Mitchell Park Horticultural Conservatory Domes

Peer Review — Precast and Cladding

WJE Considerations for Enhancement

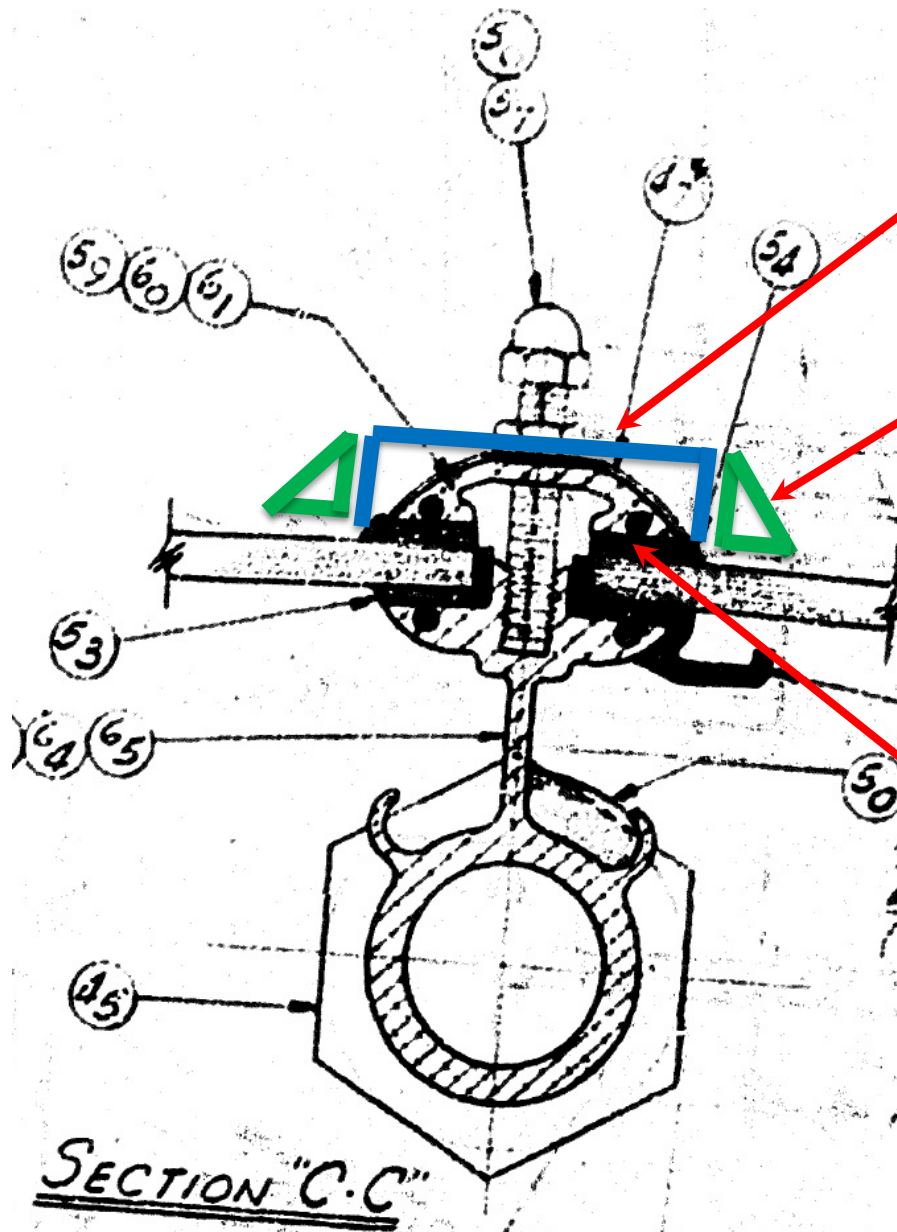
New pressure cap to enhance water tightness

New Sealant joint (wet seal)

New gasket

GRAEF observed water sitting in the hub below this elevation, which is likely causing water leakage at fittings. A self-leveling sealant can be installed to fill in the “depressed” area (GRAEF repair).

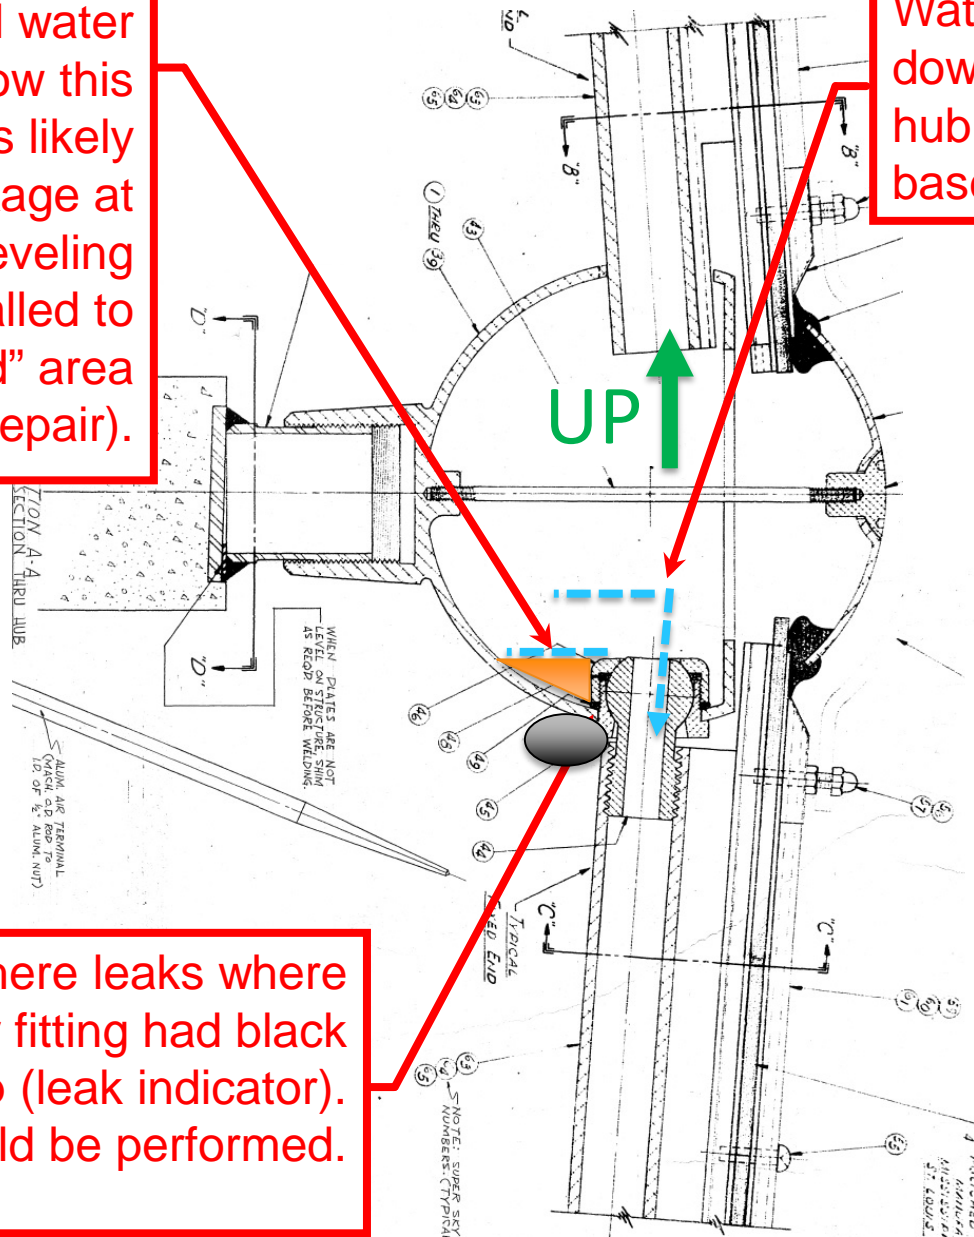
Water can then flow down the rafter at each hub and out at the base of the dome

At locations where leaks were observed, the rafter fitting had black material build-up (leak indicator). Target repairs could be performed.
